CITY OF EL PASO, TEXAS
AGENDA ITEM DEPARTMENT HEAD'S SUMMARY FORM

SUBJECT:
An ordinance changing the zoning of Lots 12, 13, 14 save & except that portion of Lot 13 previously conveyed to the State of Texas in warranty deed recorded in Volume 211, Page 313, Real Property Record, Block 52, Map No 2. of Government Hill Addition, City of El Paso, El Paso County, Texas from R-4 (Residential) to A-O (Apartment/Office). The penalty is as provided for in chapter 20.24 of the El Paso City Code. Subject Property: 4131 Trowbridge Drive. Applicant: Gateway Mission Training & Conference Center, Inc. PZRZ11-00036 **(District 2)**

City of El Paso – City Plan Commission Staff Report

Case No:	PZRZ11-00036
Application Type:	Rezoning
CPC Hearing Date:	October 6, 2011
Staff Planner:	Andrew Salloum, 915-541-4633, salloumam@elpasotexas.gov
Location:	4131 Trowbridge Drive
Legal Description:	Lots 12, 13, 14 save & except that portion of Lot 13 previously conveyed to the State of Texas in warranty deed recorded in Volume 211, Page 313, Real Property Record, Block 52, Map No 2. of Government Hill Addition, City of El Paso, El Paso County, Texas
Acreage:	0.395-acre
Rep District:	2
Zoning:	R-4 (Residential

ATTACHMENT 3: CONCEPTUAL SITE PLAN

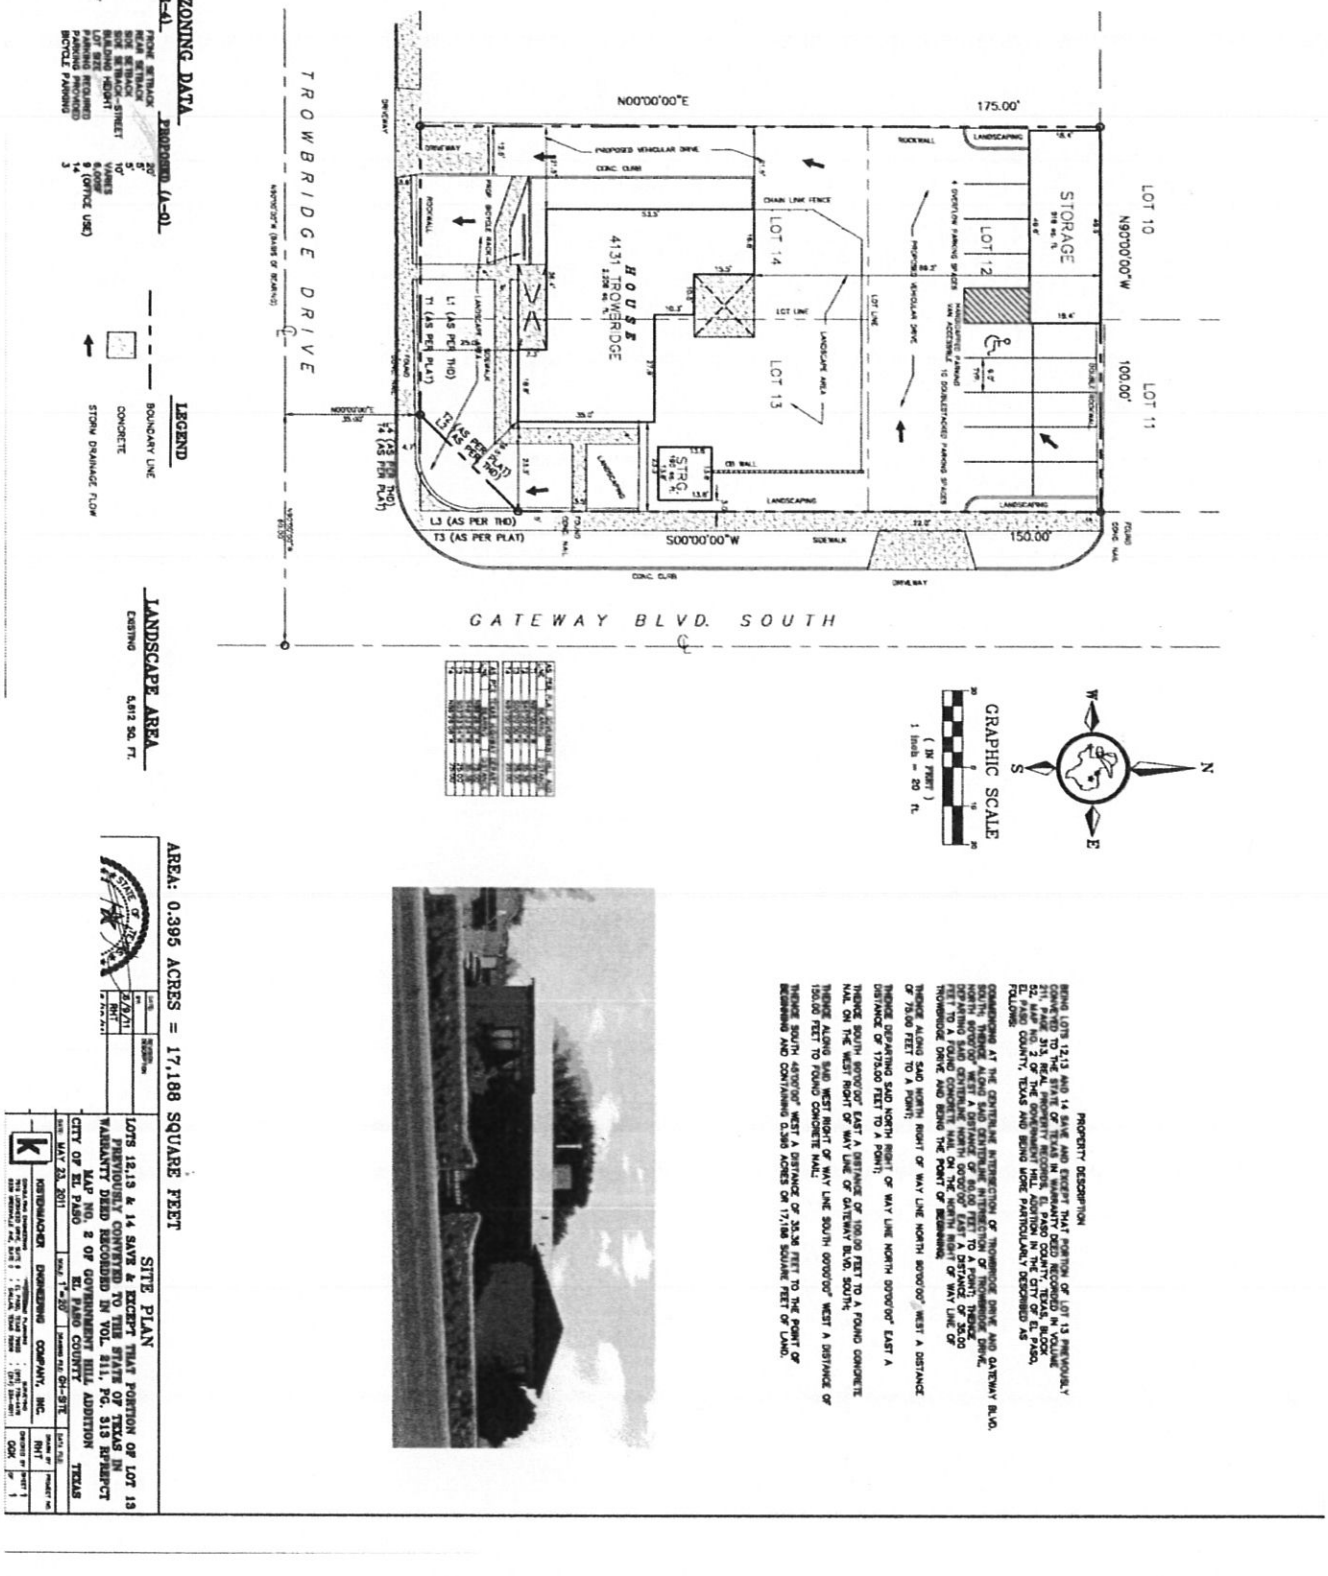
Plan review: recommends approval for zoning change, but note to owner that tandem parking is not permitted per 20.14.040 (A) zoning code.

1. Parking does not comply. No tandem parking. (Section 20.14.040)
2. The driveway facing Trowbridge Drive does not comply (Section 13.12)
3. Rockwall is encroaching on R.O.W. and requires coordination with TXDOT
4. Requires TXDOT approval for driveway on Gateway Blvd. South.
5. Provide dimensions for sidewalk.
6. Sidewalk shall be continuous across driveway and shall comply with ADA standards
7. Landscape area must not block line of sight.
